**Work Order ID 81141**

Item Name: Crosstube Turning Detail

<b>DART AEROSPACE LTD</b>	<b>Work Order:</b>	81141
<b>Description:</b> Crosstube Assembly (205/212/412 High Fwd)	<b>Part Number:</b>	D212-664-141
<b>Inspection Dwg:</b> D212-664-141 <b>Rev:</b> D		Page 1 of 1

DRAWING NO. D212-664-141	TITLE XTUBE ASSY (205/212/412 HI FWD)	REV. D	DART AEROSPACE LTD ENGINEERING ORDER		D.E.O. NO. D212-664-141-D-1	SHEET NO. SHEET 1 OF 2	SCALE NTS
DRAWN	CHECKED	MFG. APPR.	APPROVED	DE APPR.			
DATE 11.04.07	DATE 11.04.11	DATE 11.04.12	DATE 11/04/12	DATE 11.04.12

**D212-664-141/-141B  
ASSEMBLY DETAIL**

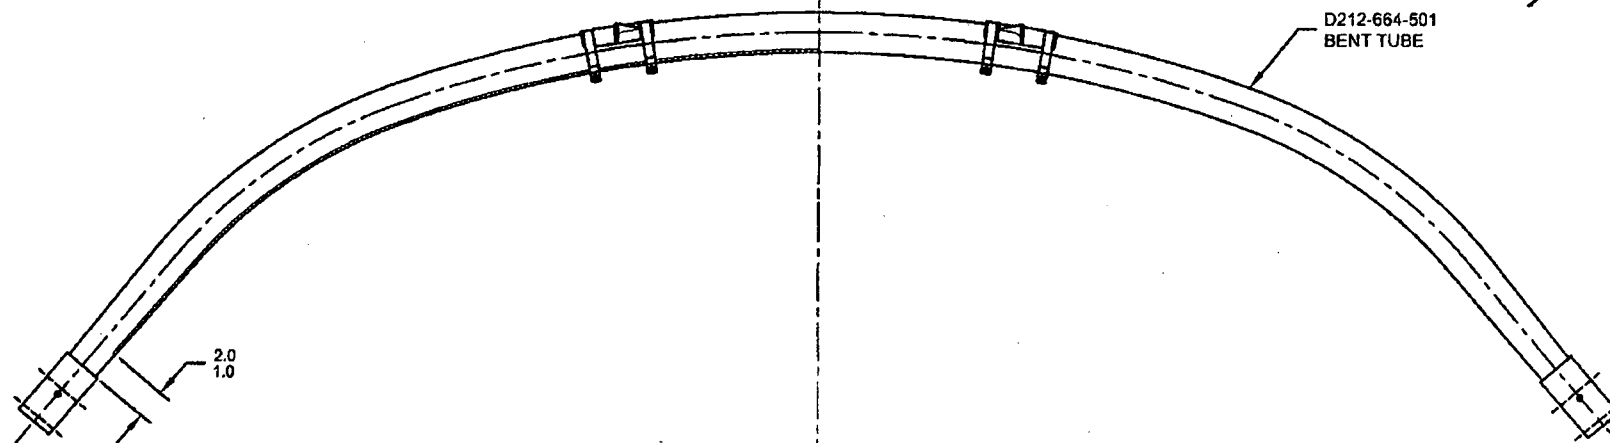
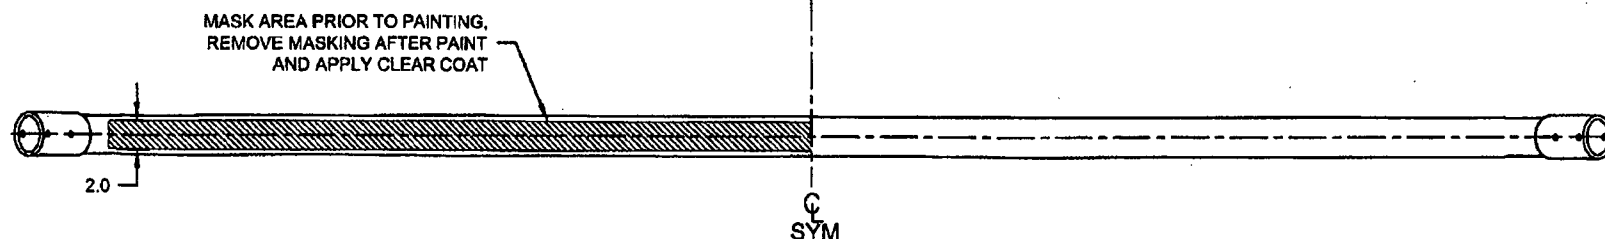
**PURPOSE:**

ADD AN INSPECTION WINDOW TO UNDERSIDE OF CROSSTUBE.

NOTES 2 OF SHEET 1 IS AMENDED AS FOLLOWS:

- 2) FINISH: CHEMICAL CONVERSION COAT PER DART QSI 005 4.1  
PRIME INSIDE AND OUTSIDE PER DART QSI 005 4.2  
MASK UNDERSIDE OF CROSSTUBE AS SHOWN (HATCHED AREA) AND  
PAINT OUTSIDE PER DART QSI 005 4.2  
REMOVE MASKING AND APPLY CLEAR COAT

**IS:**

**WAS:**
